MFN-156-80
REE-054-80

SUBJECT: ADDITIONAL INFORMATION ON NEDO-24259, "GENERIC INFORMATION
FOR BARRIER FUEL DEMONSTRATION BUNDLE LICENSING"

RESPONSE TO REQUESTS BY NRC ON NEDO-24259

RAMP TEST RESULTS - REFERENCES

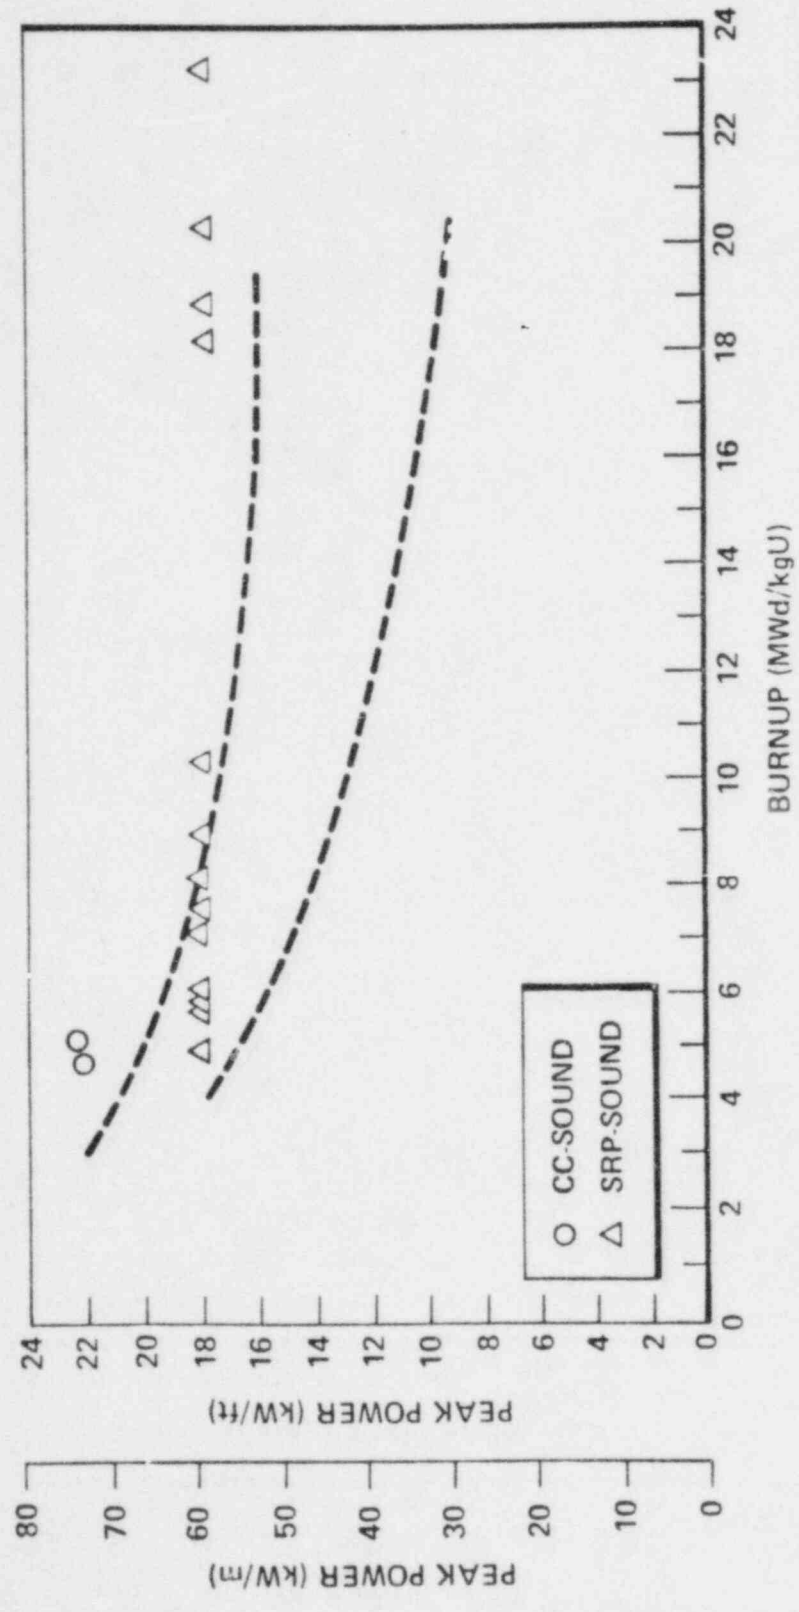
Although the report is intended to provide a basis for the demonstration irradiation of PCI-resistant fuel in a commercial power reactor, hardly any background discussion is provided on the barrier fuels test program. Although references are cited in the text, it is desirable to have a brief summary discussion of the barrier fuel test program. The discussion should focus on (a) test results that have indicated that this particular barrier material and design is effective against PCI failure and (b) how the tests to date support the belief that the insertion of the demonstration bundle in Quad Cities Unit 2 will not result in reduced safety margin or increased fission product release. The response to this question should be incorporated into NEDO-24259, perhaps as an appendix, following completion of this review, so that the report constitutes a "stand-alone" document (which references other documents containing greater detailed information on specific points).

The requested background information is provided in the attached text (Attachment A1), which has been excerpted from the report GEAP-23773-2 (Reference 6 of NEDO-24259). This information is a summary of Phase 1 of the program, "Demonstration of Fuel Resistant to Pellet-Cladding Interaction". Notice that within the Phase 1 work fuel test data were obtained that indicated that barrier fuel of the Zr-liner type had PCI-resistance to power ramps up to 18 KW/ft at a burnup of >16 MWd/kg U. More recent data are available which show similar PCI-resistance of the barrier fuel to a burnup of >23 MWd/kg U. These data are from ramp tests in a test reactor and are shown in Attachment A2. The portion of the figure on A2-2 within the dotted region shows the power burnup range in which failures were observed in reference fuel (conventional Zircaloy-2 cladding). The Zr-liner fuel successfully withstood a ramp beyond the upper curve which marks the range in which 100% of the reference fuel

rods have failed. The superior performance of the barrier fuel under severe PCI conditions is evident.

SCHEDULE FOR BARRIER FUEL DEMONSTRATION PHASE 2

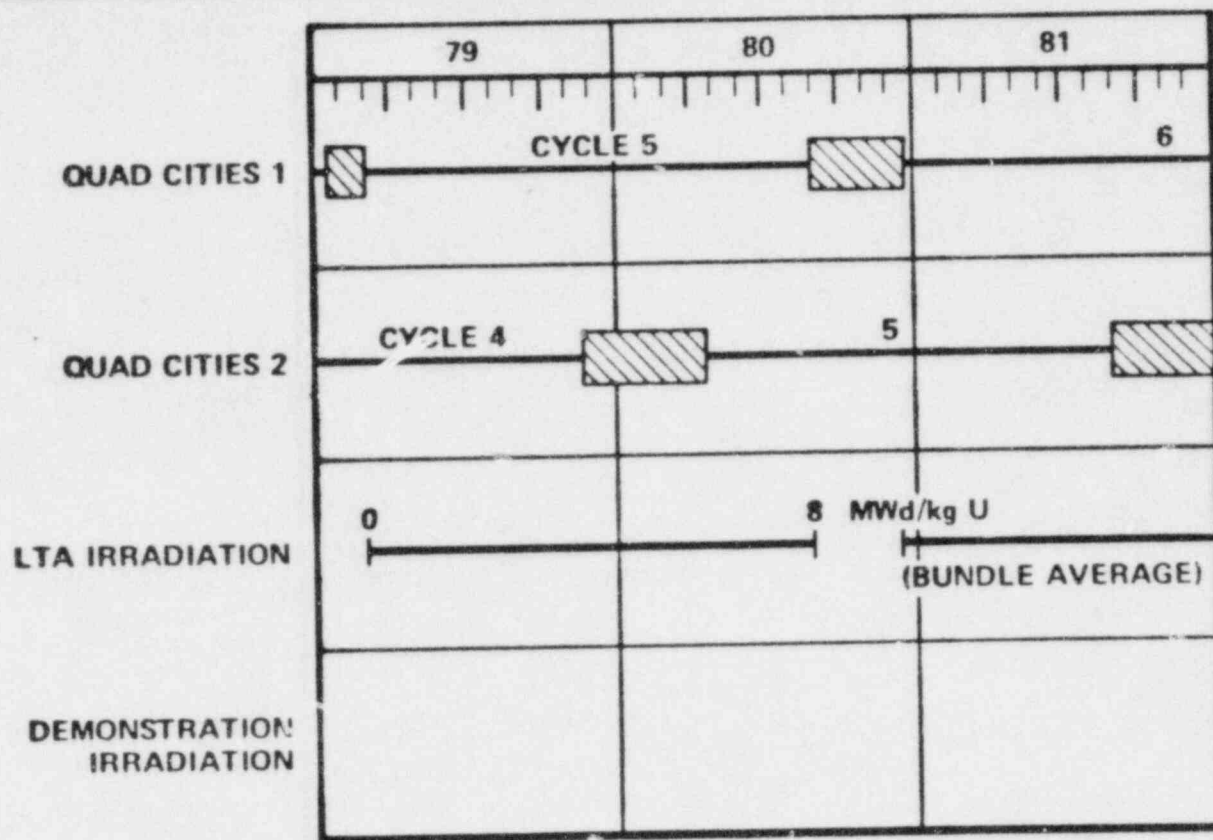
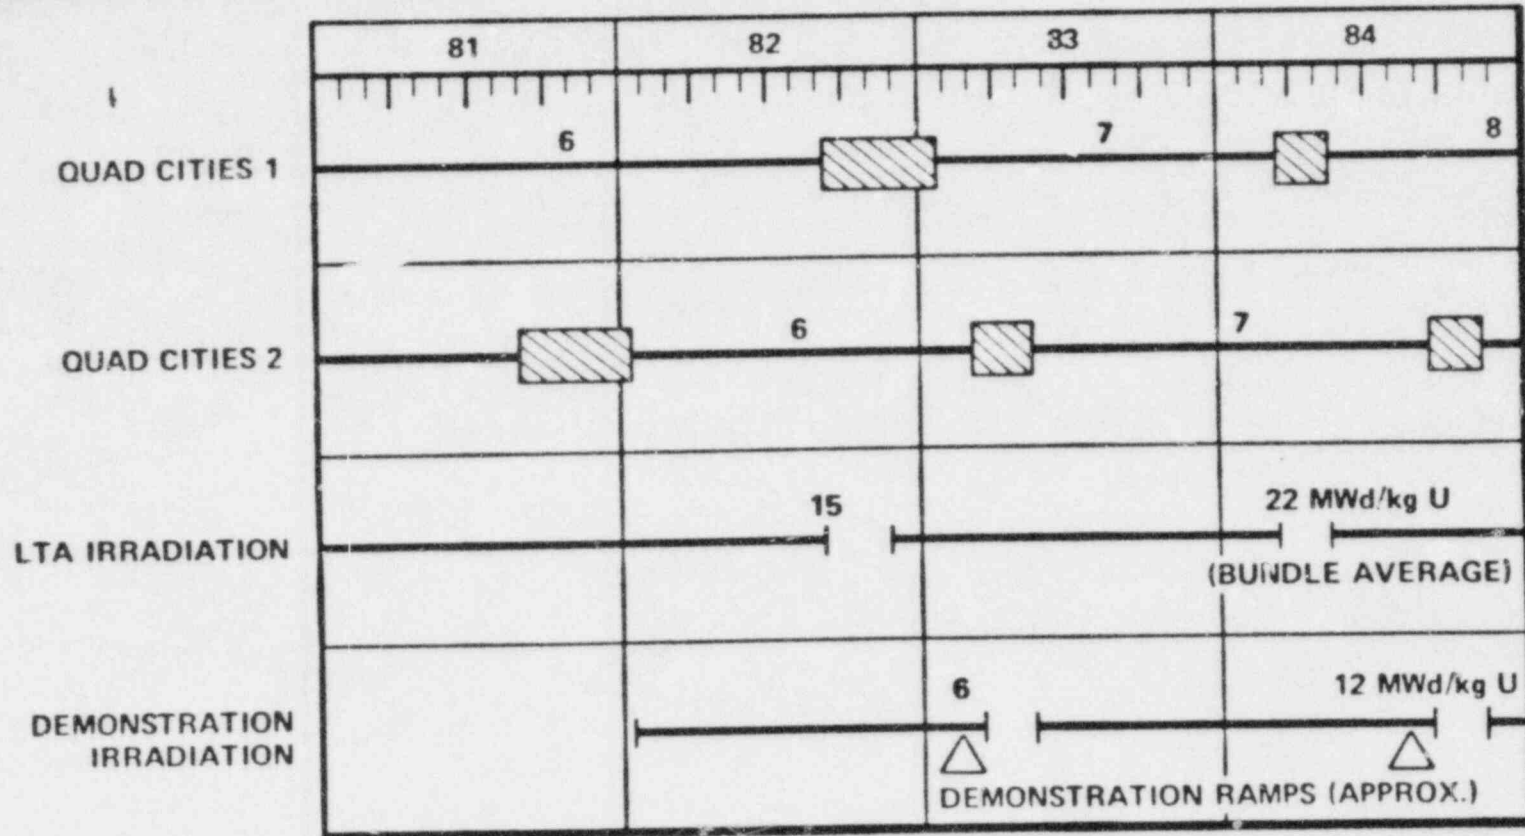
The report contains no description of key milestones or schedules. Although some of that information was presented at the March 25, 1980 meeting between GE, DOE, Commonwealth Edison, and NRC staff, it would also be desirable to have that information in writing (to be incorporated into the report) along with a discussion of the intended plan for timely reporting of pertinent information to NRC regarding the results of the demonstration.

Milestones and target dates are shown in Attachment A5. All data generated in this program are reported informally and in a preliminary manner each month, with formal progress reports at semiannual intervals. Several members of the NRC staff now receive the semiannual report.
